Docket No. 50-346

License No. NPF-3

Attachment 4

I. Change to Davis-Besse Nuclear Power Station Unit 1, Appendix A, Technical Specifications 3.4.8, Table 4.4-4, Figure 3.4-1 and Bases.

FIGURE 3.4-1

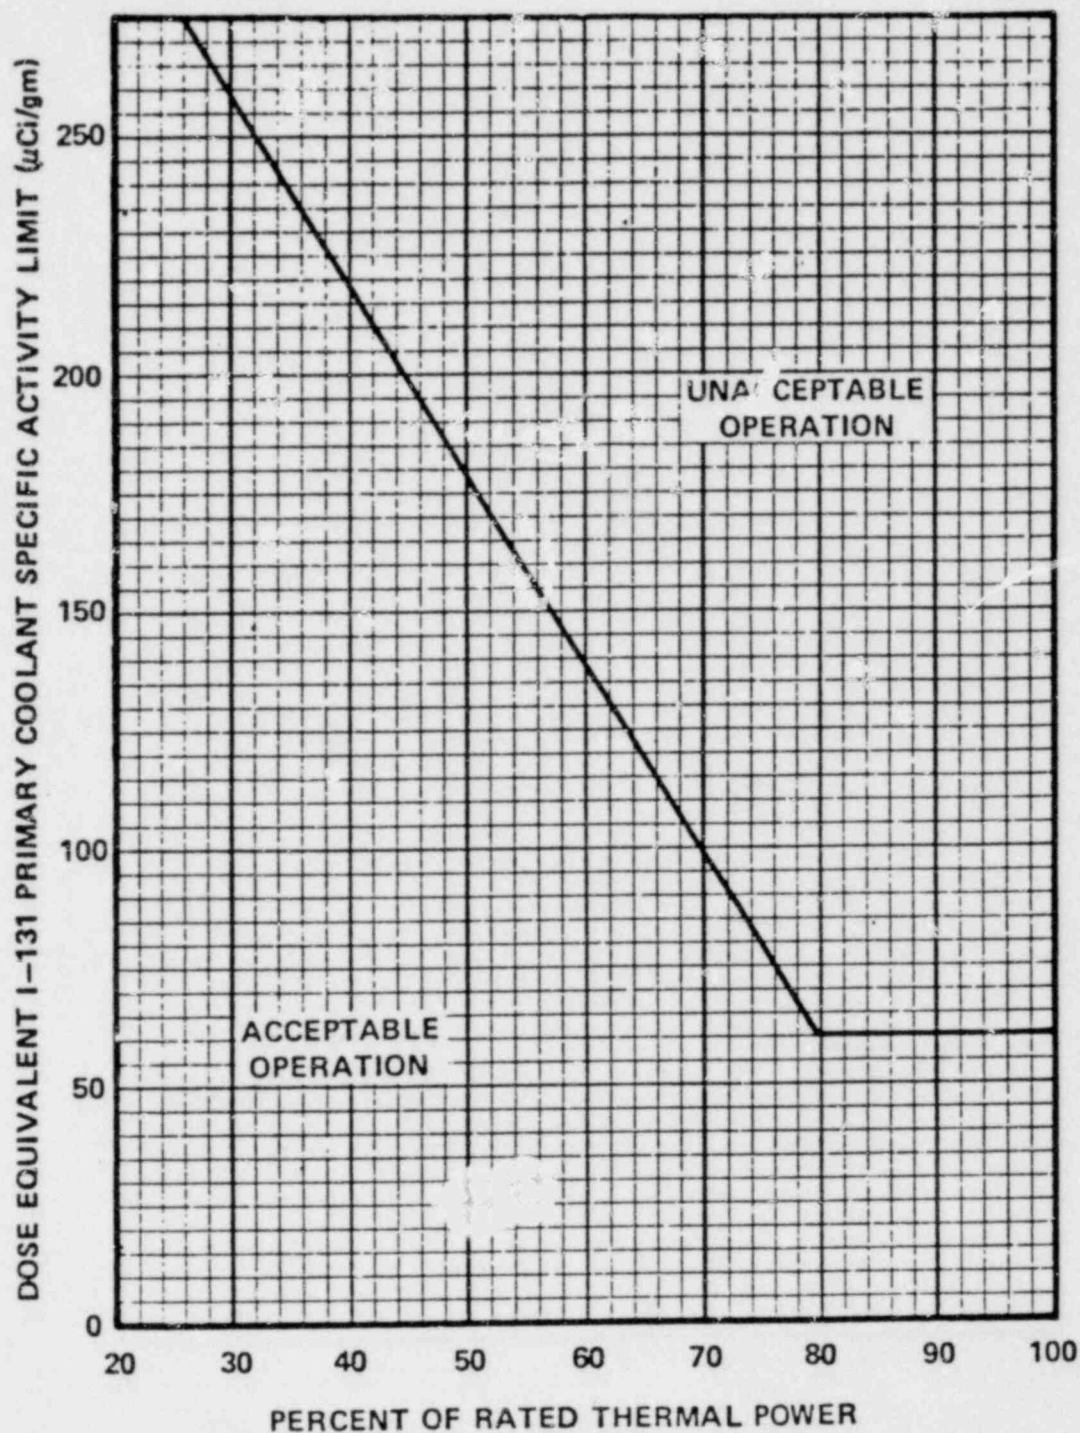
DOSE EQUIVALENT I-131 Primary Coolant Specific Activity Limit Versus Percent of RATED THERMAL POWER with the Primary Coolant Specific Activity $> 1.0 \mu\text{Ci/gram}$ Dose Equivalent I-131

3.2

This amendment request proposes a change to the dose equivalent I-131 concentration in the reactor coolant system from 1.0 uci/gm to 3.2 uci/gm. The Technical Specifications limitation on the Dose Equivalent I-131 concentration in the primary coolant is established to insure that the resulting two hour doses at the site boundary will not exceed a small fraction of the 10CFR100 limit following a design basis steam generator tube rupture accident in conjunction with an assumed steady state primary to secondary leakage rate of 1.0 gpm. The two hour dose at the site boundary for 3.2 uci/gm dose equivalent I-131 has already been analyzed in FSAR Section 15.4.2.3 for the design basis steam generator tube rupture accident. The resultant 0.23 Rem whole body and 27.1 Rem thyroid dose as presented in FSAR Table 15.4.2-3 are below one tenth of the 10CFR100 limits of 25 Rem for whole body and 300 Rem for thyroid. The FSAR doses are calculated assuming 1% defective fuel rods operated at steady state with 1 gpm primary to secondary leakage rate prior to the postulated double-ended rupture accident of one steam generator tube. The resulting site boundary doses from a less severe rupture should be much lower than the case mentioned above since the activity released is far less in magnitude. Based on the above, it is concluded that the original premise of doses being a small fraction of 10CFR100 limits is still met.
